IMPORTANT SAFETY RECALL
See enclosed VIN list

September 2022
FL948
NHTSA #22V-532 (School Bus)

Subject: Thomas Built Bus Minotour Incorrect Tire Label

Vehicle data label

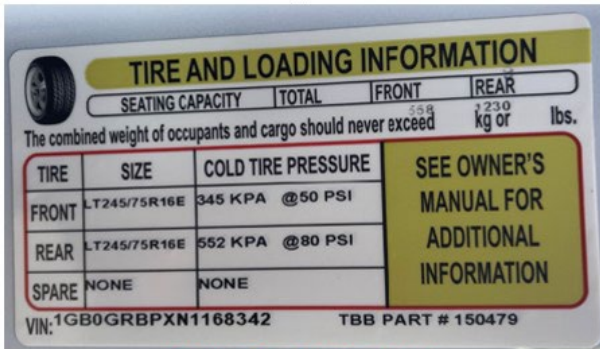
The vehicle Information Label, tire, and Loading Information Label state incorrect tire size information. An incorrect tire size label can increase the risk of a crash.

Shown: Correct data on label

New label(s) will be mailed to customers with the correct tire size information, free of charge.

Applied to the Front Bulkhead

Tire and Loading Information

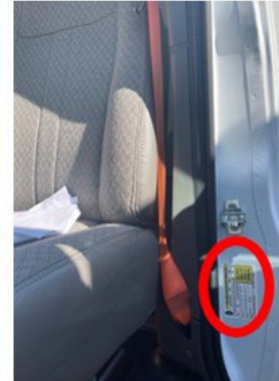
Shown: Correct data on label

Applied to driver door post
